**Subject: Response to Request for Additional Information (RAI) numbers (25, 306,
and 319) for ESBWR Pre-application Review.**

Response to NRC RAI numbers (25, 306, and 319)

RAIs NEDE-32176P, "TRACG Model Description"

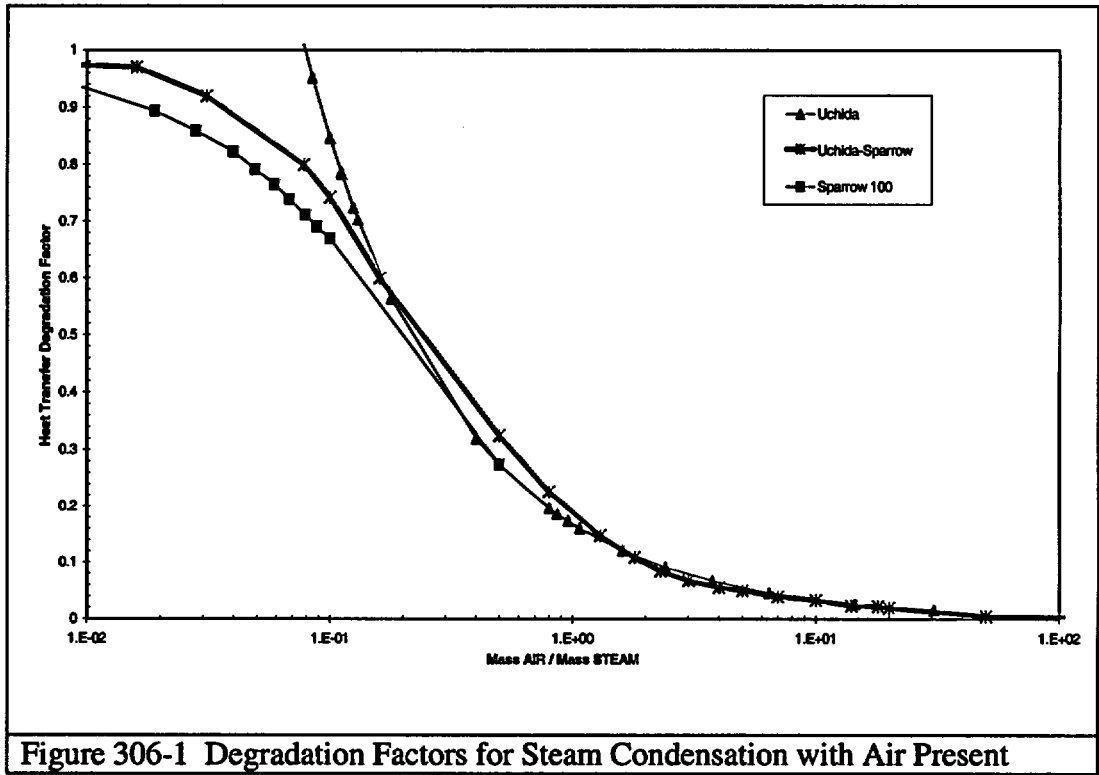
- Q306.2. How was the Sparrow-Uchida degradation factor obtained? Does the correction factor include any bias based on the Sparrow or Uchida data? Is it a "best-estimate" correction? What is the uncertainty in this correction factor and is it considered in the calculations?

- R306.2. The precise origin of the tabulated values that are referred to as the Sparrow-Uchida degradation factors is not known. There is reason to believe (as will be demonstrated) that these values were obtained by merging the separate results from Sparrow and Uchida. The tabulated values in the code are used to degrade the condensation heat transfer at the free surface between the mixture and vapor regions when a water level is predicted. The values are tabulated in the code as the ratio of air-to-steam density and are presented graphically in Figure 6.5-1 of NEDE-32176P, Rev. 2. That figure has been reproduced here as Figure 306-1 and additional curves have been added to allow the Sparrow-Uchida degradation curve to be compared with the curves attributed individually to Uchida and Sparrow.

The curve marked "Sparrow 100" in Figure 306-1 is obtained from Figure 10.4 from Collier's book. Collier's book is cited in NEDE-32176P, Rev. 2 as Reference [6.5-11]. Collier attributes this and 3 other curves shown in his Figure 10.4 to Minkowycz and Sparrow. The "Sparrow 100" curve that is shown here is the forced convection curve corresponding to a bulk mixture temperature of 100 C. It is clear that all four of the "Sparrow" curves are for relatively low mass fractions for air in steam over the range from 0.0 to 0.1. Here in Figure 306-1, the lowest point in the Sparrow curve has been extrapolated assuming the same slope as suggested by the previous two points.

The so-called Uchida correlation as presented in Eq. 6.6-81 of NEDE-32176P, Rev. 2 cannot apply for relatively low mass fractions because it obviously predicts the wrong trend as the mass of air approaches zero and in fact is undefined in the limit of zero air mass. For Uchida, the functional form of the degradation factor is obvious but the composite

heat transfer coefficient (HTC) must be divided by the undegraded heat transfer coefficient (HTCo) to obtain the degradation function. Appropriate values for HTCo are in the range from around 40 to 70 ($W/m^2/K$). The plots presented here uses $HTCo = 64.19$ to convert the Uchida heat transfer coefficient expression into the degradation function.

Notice from Figure 306-1 that a transition from the Uchida to the Sparrow degradation functions is needed because the degradation factor due to Uchida alone increases unrealistically for the smaller air mass fractions. The suggested Uchida-Sparrow form does not have this undesirable behavior.
